Service Bulletin SB-0043

Subject: Flap Compensation Potentiometer Removal

Affected Model(s): E1000 GX

FIGURE 1: Flap Compensation Potentiometer Removal (Sheet 1 of 2)

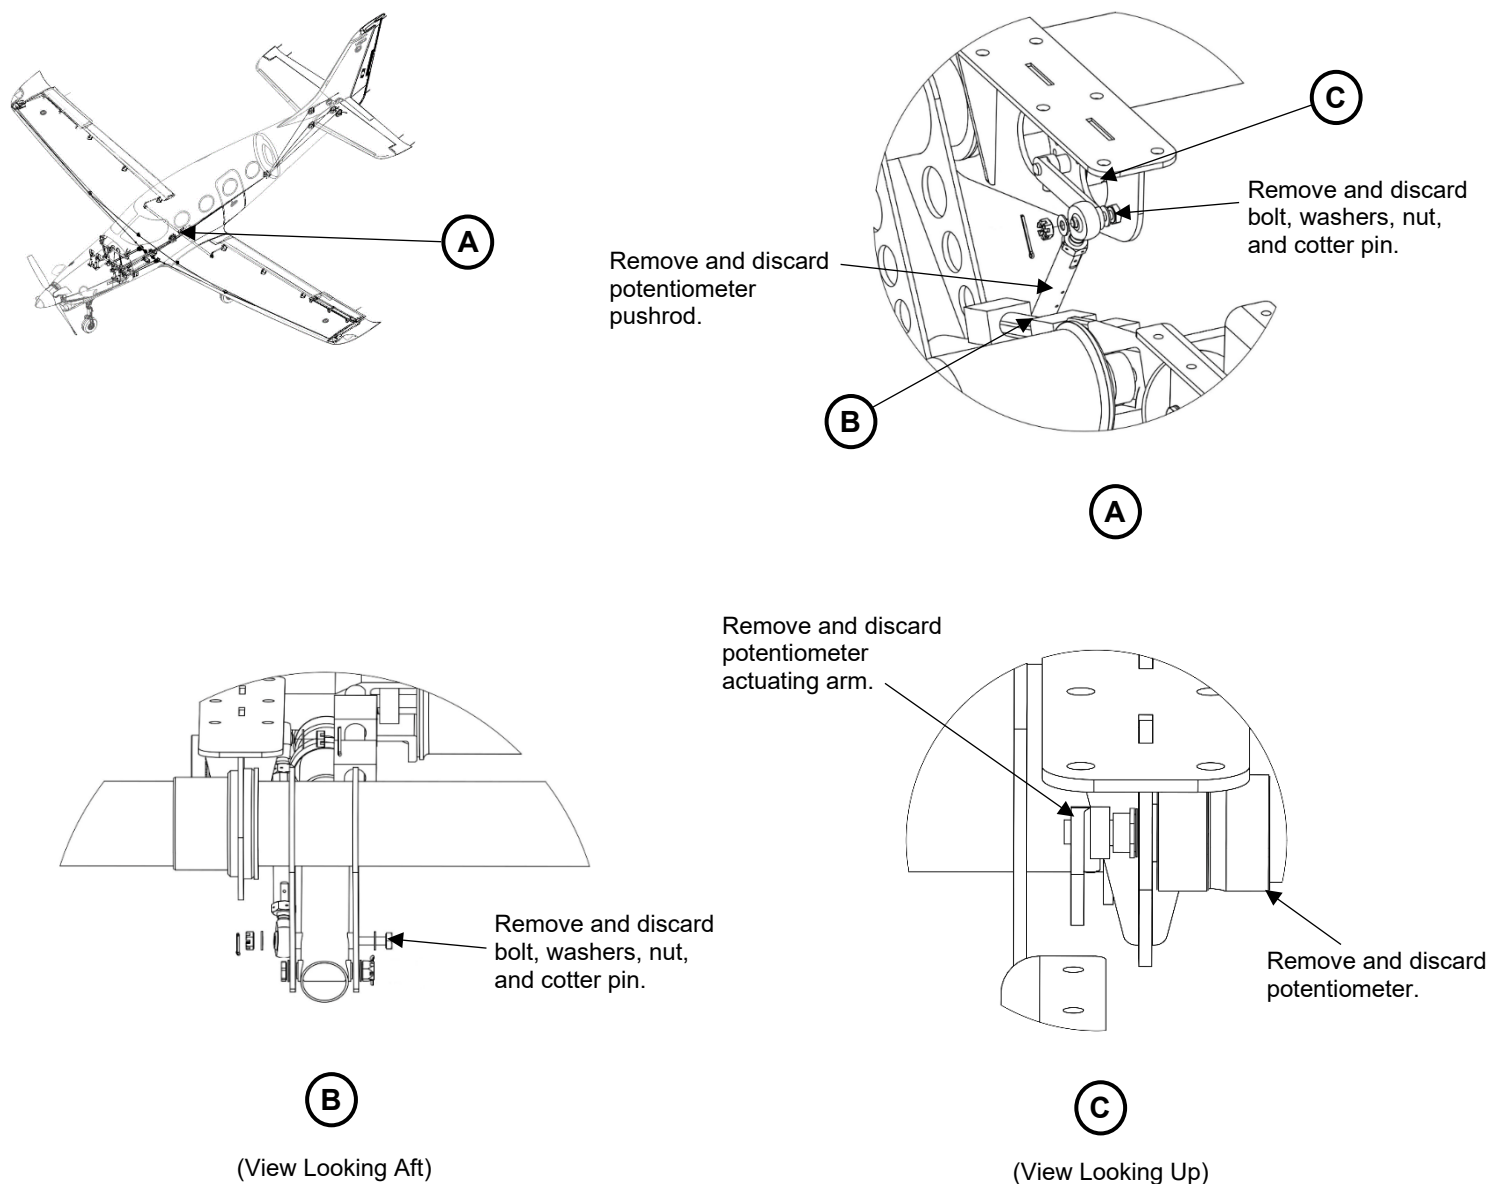
- a. Disconnect the flap potentiometer electrical connector (J532-P532).
 - b. Remove the cotter pins, nuts, washers, and bolts that attach the potentiometer pushrod to the flap actuator body and the potentiometer actuating arm. Discard the pushrod and hardware.

- c. Loosen the set screw that attaches the actuating arm to the potentiometer. Remove and discard the actuating arm.
 - d. Remove the nut and lockwasher that attach the potentiometer to the flap support bracket. Discard the potentiometer.

FIGURE 1: Flap Compensation Potentiometer Removal (Sheet 2 of 2)

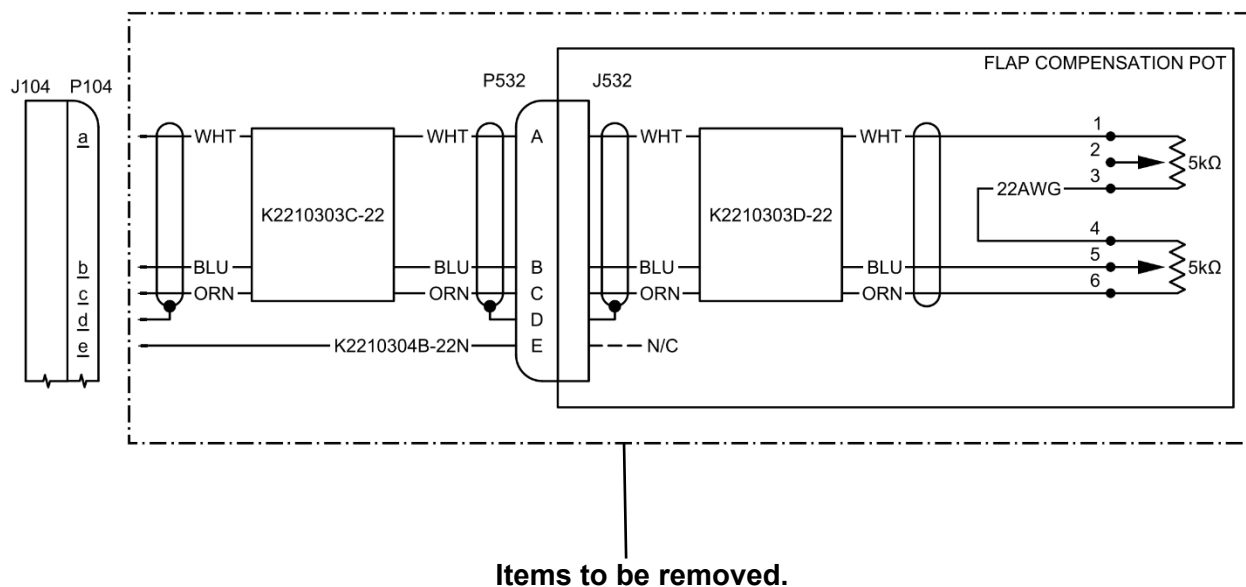
- e. Disconnect the following wires from connector P104, refer to Figure 1, sheet 2:
 - i. K2210303C-22 WHT
 - ii. K2210303C-22 BLU
 - iii. K2210303C-22 ORN

- iv. K2210303C-22 (SHLD)
 - v. K2210304B-22N
 - f. Install MS27488-20-2 sealing plugs in the open sockets in connector P104.
 - g. Discard connector P532 and its harness.
